JOINT REGIONAL PLANNING PANEL (Hunter and Central Coast)

Supplementary Assessment Report and Recommendation Cover Sheet - February 2017

| JRPP No | 2016HCC028 | | |

PROPOSED: MIXED USE COMMERCIAL DEVELOPMENT

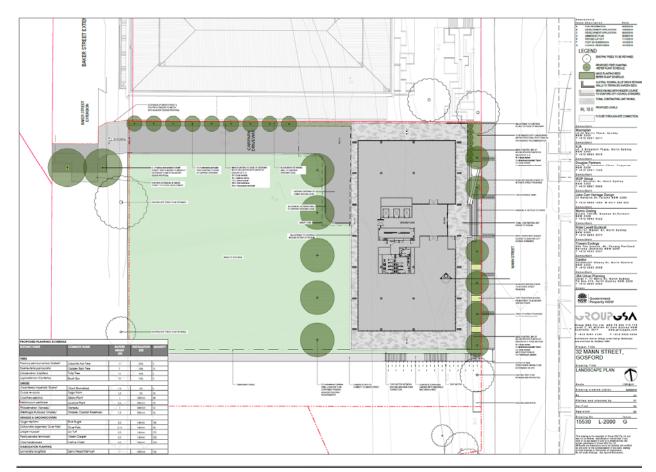
5. Confirmation that the proposal will not adversely affect the tree located near the northern boundary on the adjoining "ATO" site, which is required to be retained under the consent for that site.

The proposed building is located 3.1m from the trunk of tree No TO68 which is located on the adjoining site. Under the conditions of consent for the commercial building on the adjoining site, Tree TO68 is to be retained and the electricity substation was relocated so as to ensure retention of the tree.

The applicant has submitted amended plans which remove any paving, walls and stairs in the immediate vicinity of the tree in the main building envelope. The applicant has submitted additional information from Travers Bushfire and Ecology that states that by removal of paving and the retaining wall in the vicinity of the tree, the proposed building will not impact more than 10% of the Structural Root Zone (SRZ) of the tree. (**Refer attachment 8**).
